**FRIENDS
OF THE
RIVER**

April 29, 2005

Re: Comments on Battle Creek Restoration Project SEIS/REIR

SNTEMP Figure -7. Validation for Mainstem Battle Creek

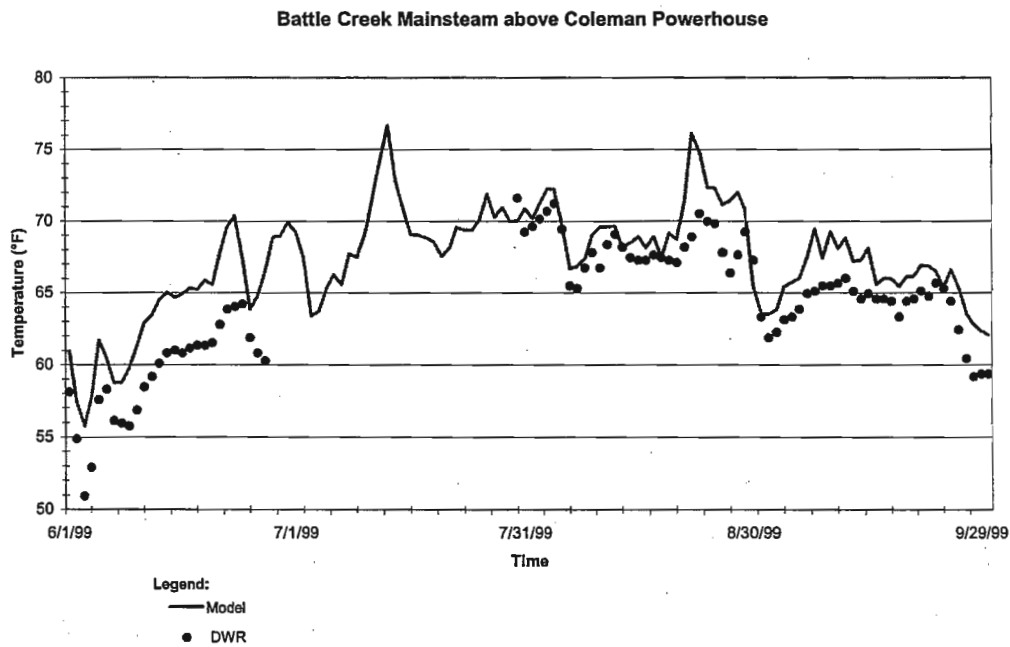
The 1999 validation test shows SNTEMP overestimated mainstem temperatures by 3-5°F in June, and 1-4°F in September. Figures T-1 to T-8 show the mainstem often at or above the upper limits for many life stages of target species. Accounting for the SNTEMP modeling error (which would affect all alternatives), the underestimate of Alt B "normal" flows, and the interannual variability of Alt B flows, would show substantially more viable habitat in the mainstem of Battle Creek under Alt B. Because these uncertainties bear materially on

Conservative validation temperature correction estimate of 1°F for mainstem June and September (all alternatives) is based on SNTemp Figure 7, which shows model predictions in 1999 consistently exceeded measured temperatures in the mainstem. SNTemp Table 1⁶ states that the 1999 validation study showed a mean error of 2.52°F and a probable error of ±2.16°F for the mainstem. Notes to SNTemp Table 1 cite a lack of cloud cover data for 1999, but this did not affect the accuracy of model predictions for other stream reaches. An additional note cites a lack of accretion flow data for the mainstem, but this note's meaning and effect could not be determined.

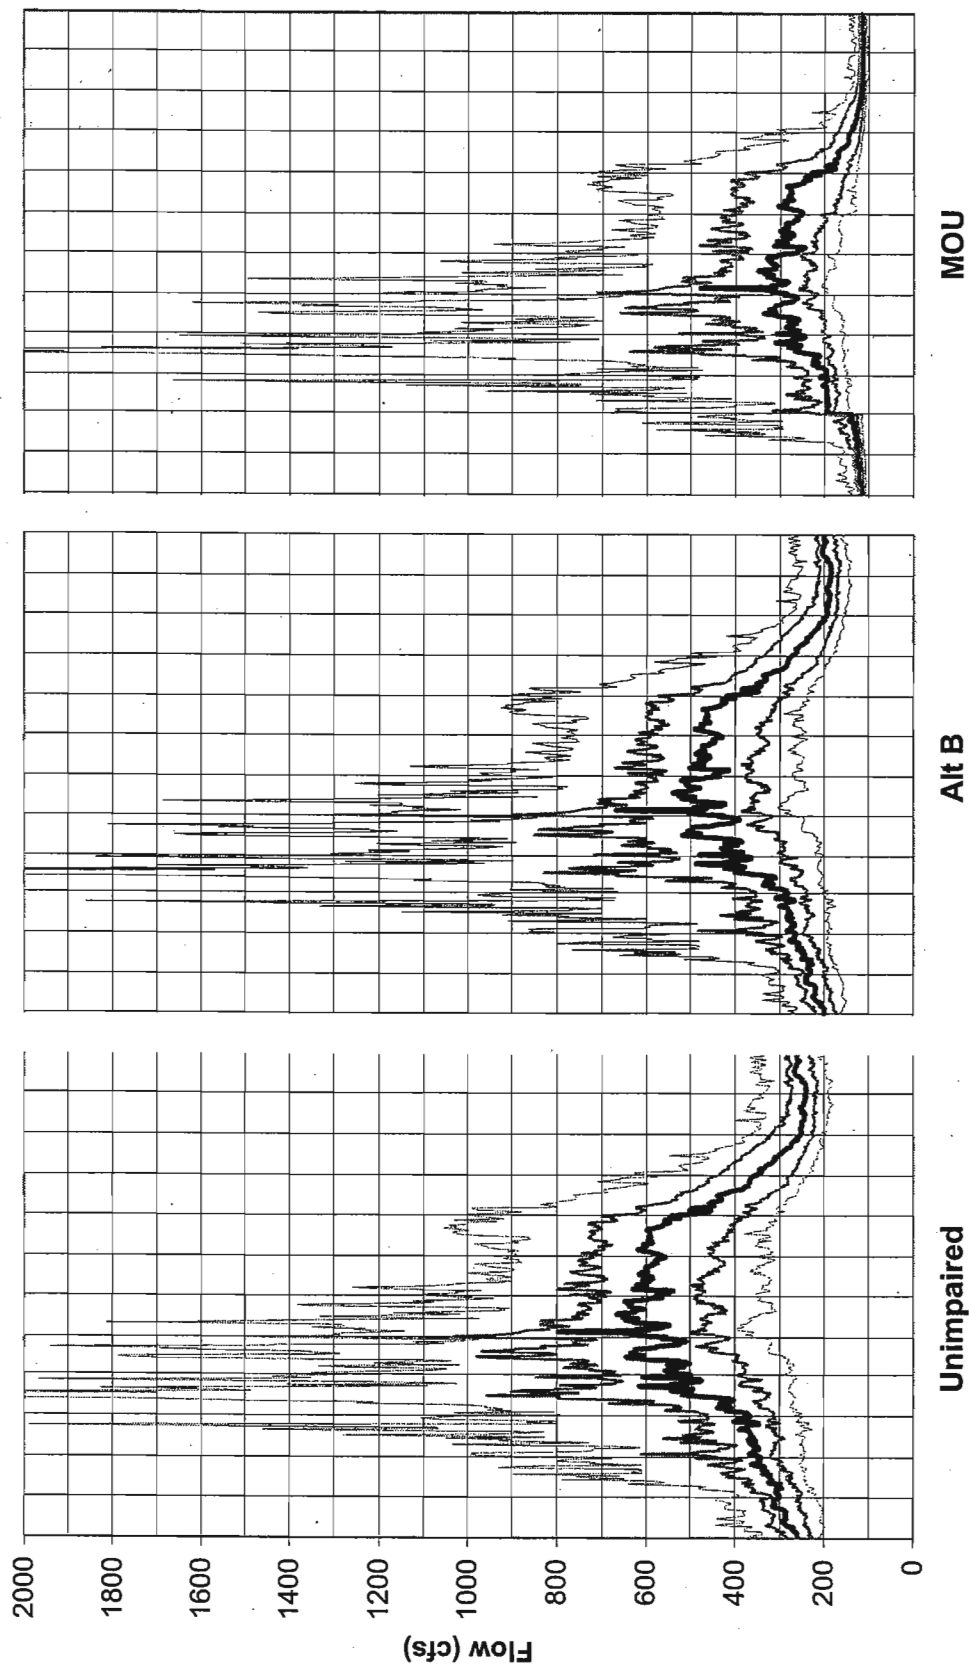
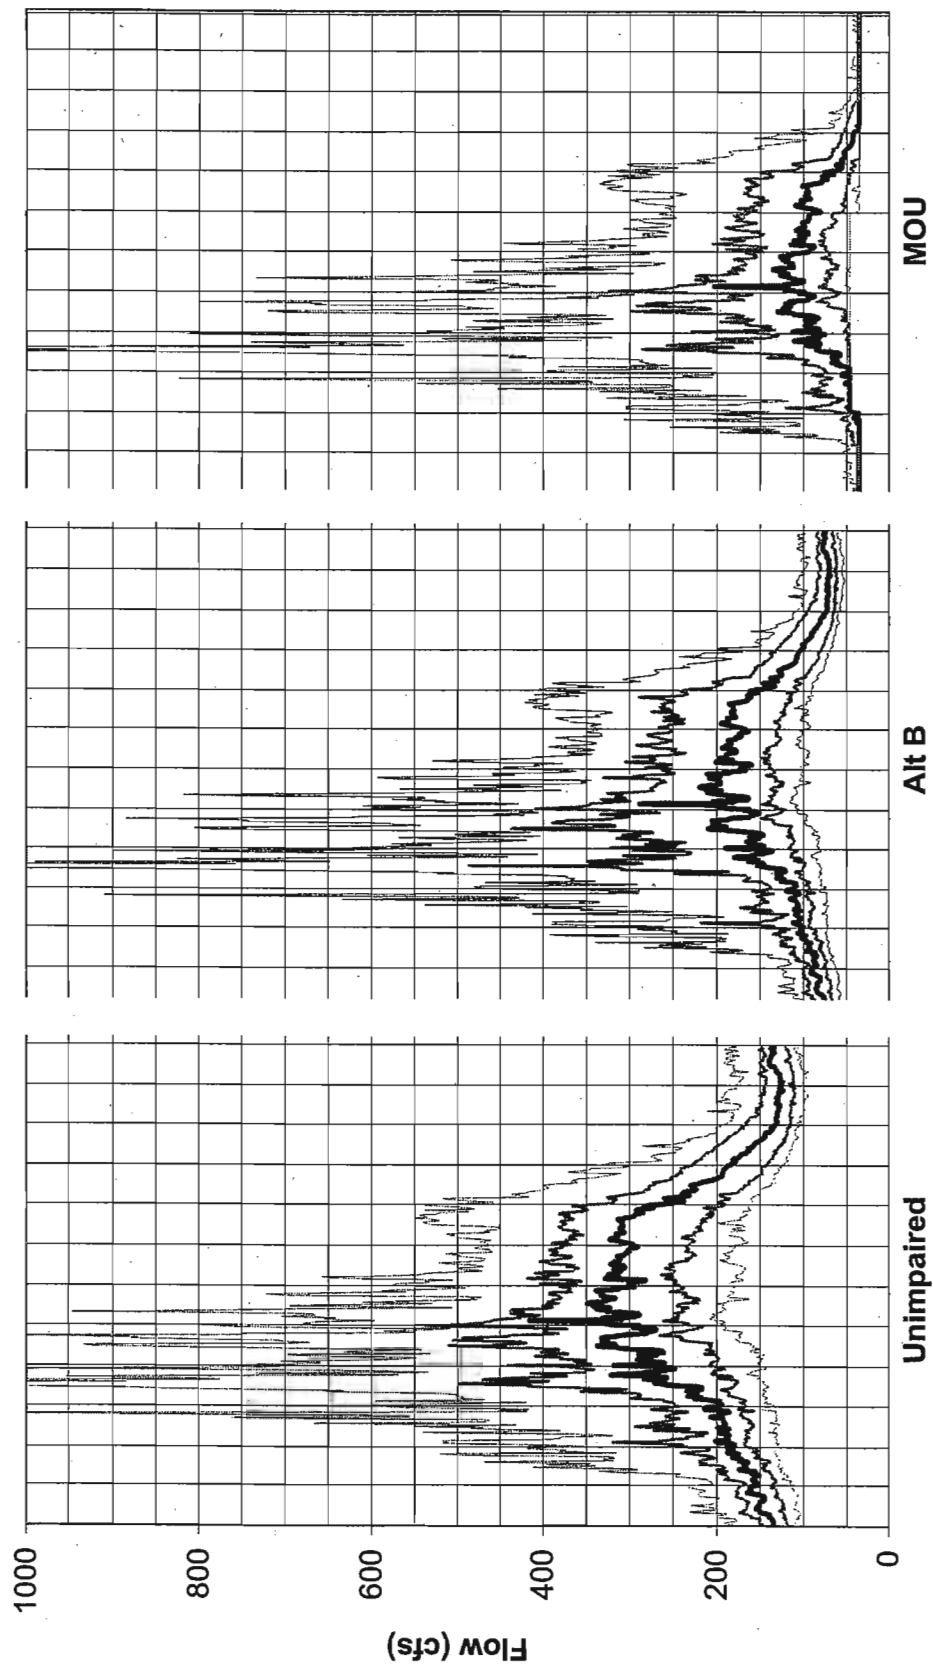
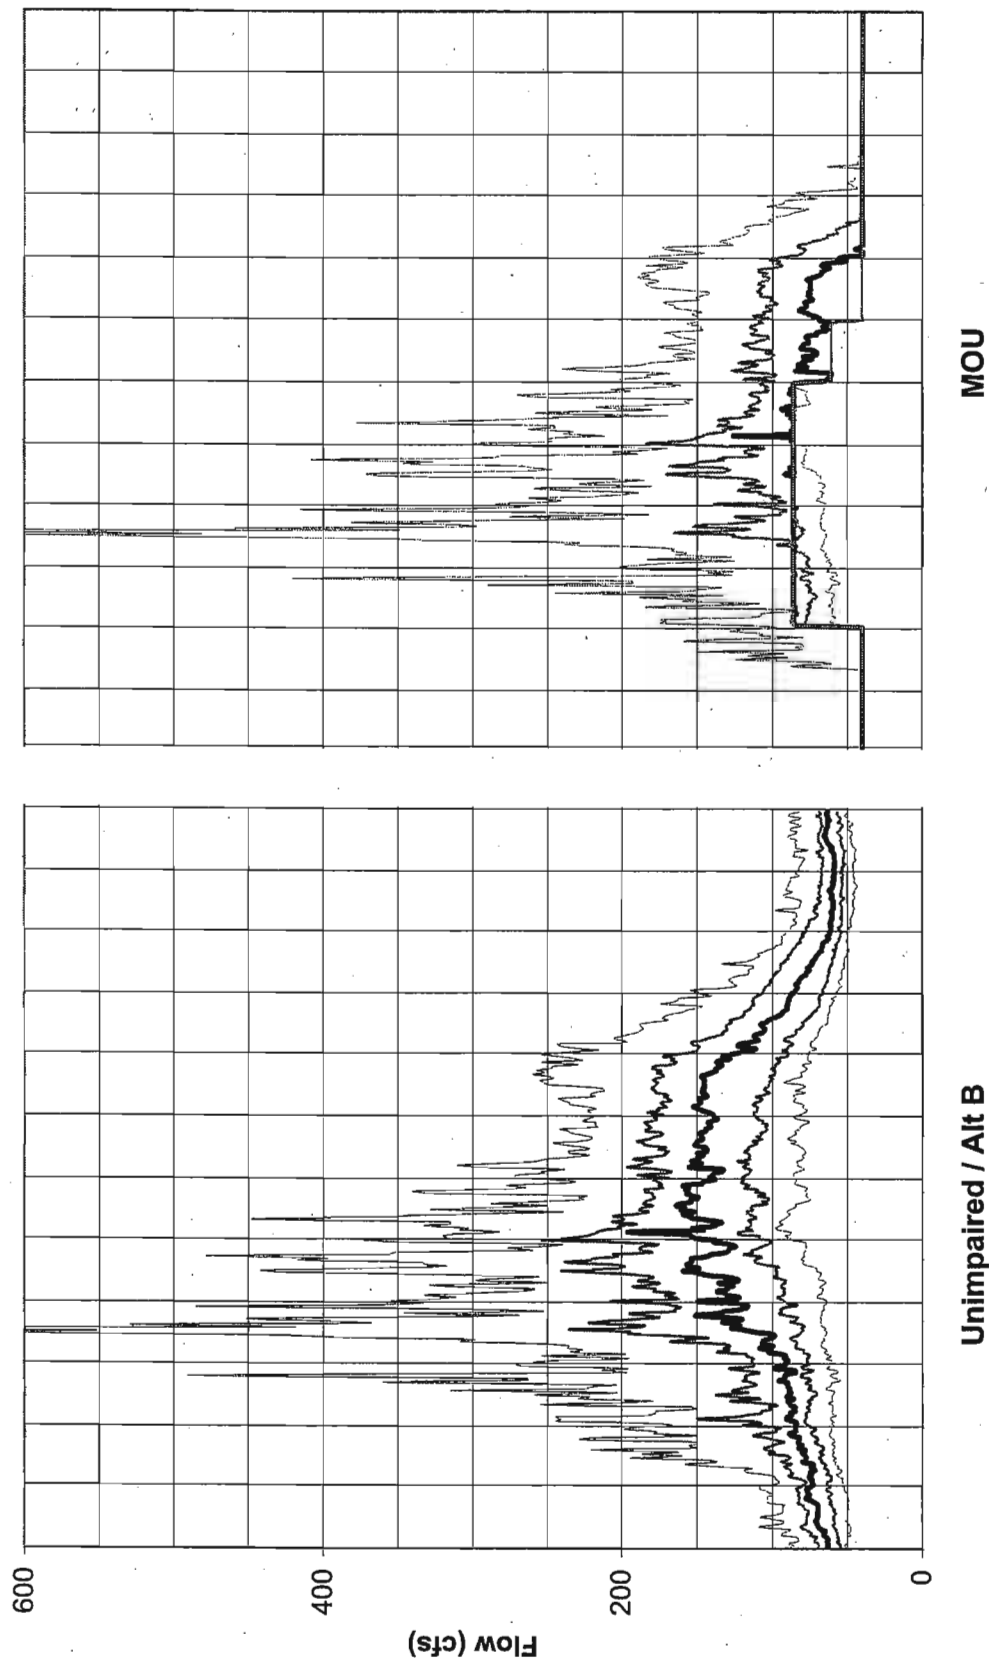
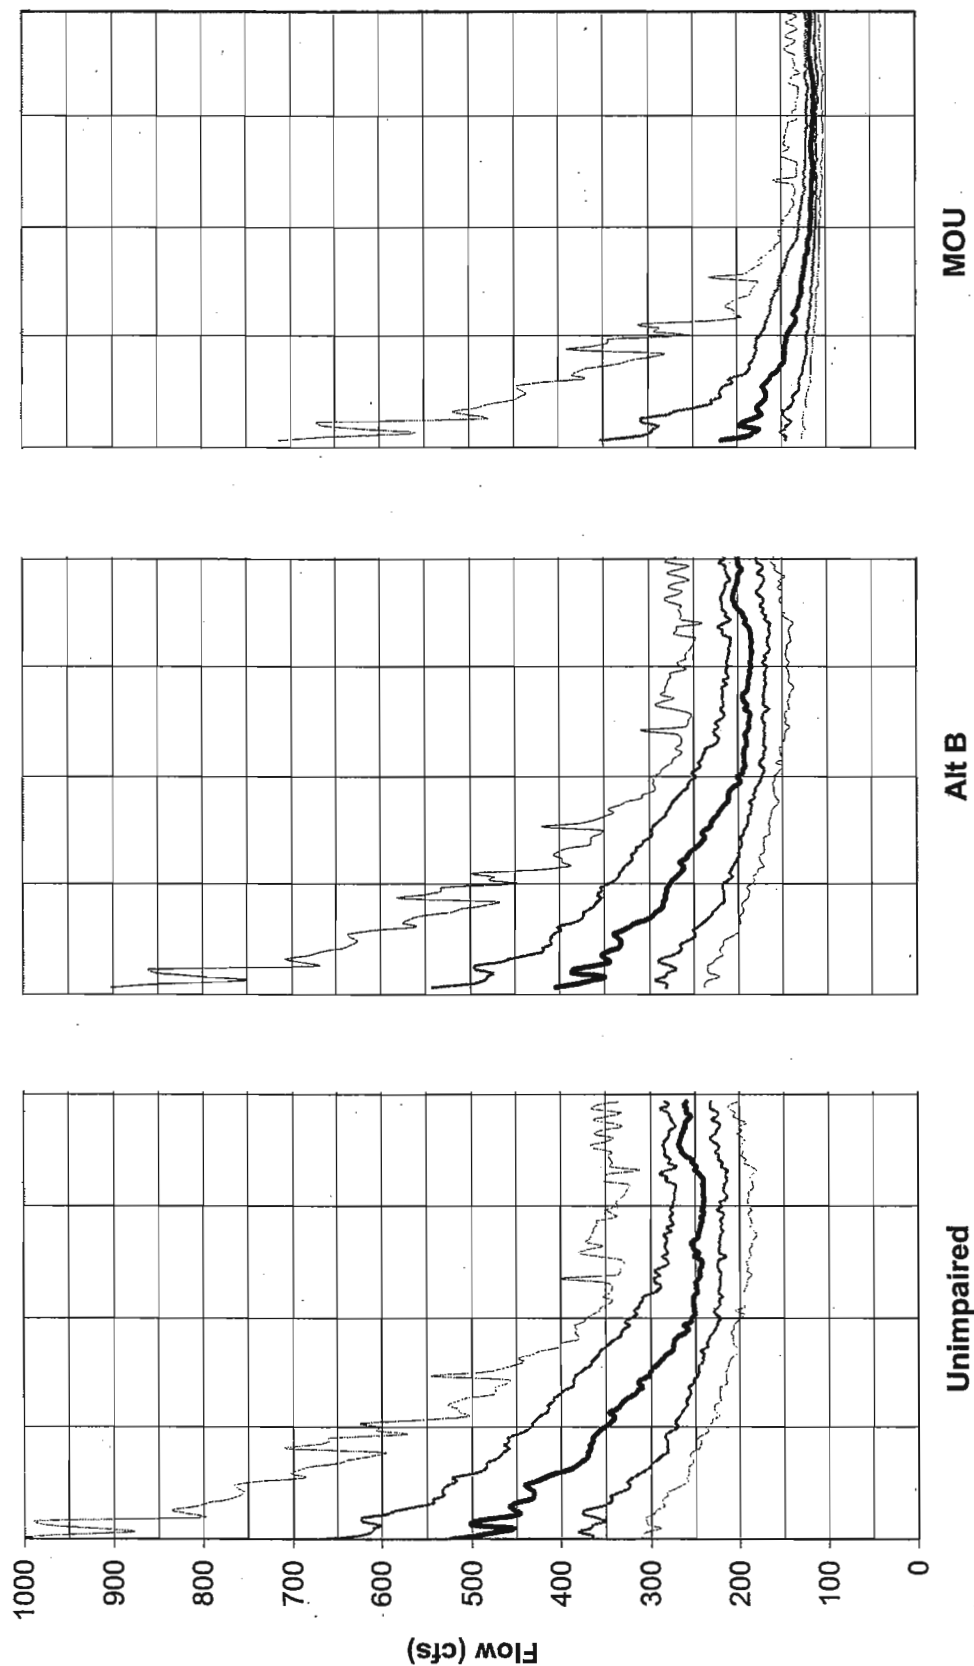
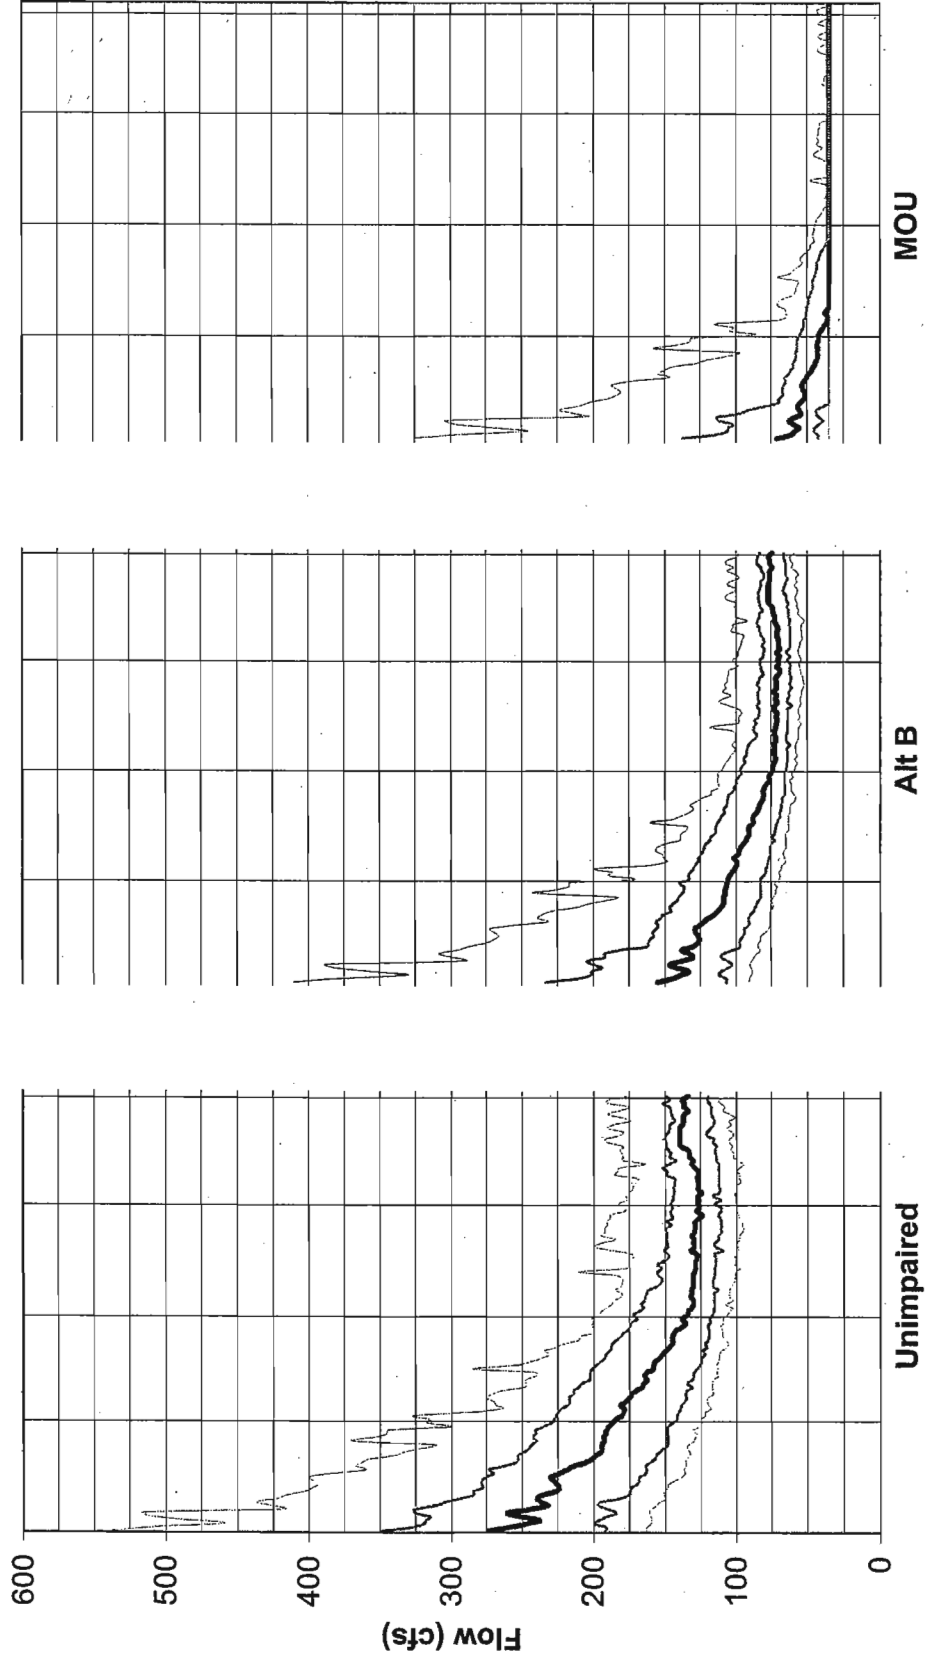
- **Magnitude.** Figures S-1 through S-6 compare unimpaired, MOU and Alt B synthetic water years using the 10th, 30th, 50th, 70th, and 90th percentile daily flows from the years 1962-2002 (1997 was excluded due to an incomplete record). While winter storm events are generally comparable for all alternatives, Alt B streamflows in spring, summer, and fall are significantly higher than MOU flows for all reaches and water year types: 50-55% more over the course of the year, and 80-130% more in summer. Unimpaired and Alt B flows show significant interannual changes in late summer/early fall low flow periods, whereas the MOU falls to the same, substantially lower flow for each reach and year type. Interannual baseflow variability under Alt B would cause physical habitat, temperature, and passage conditions to vary somewhat from year to year, allowing fish to exploit outstanding habitat conditions on a recurring basis.
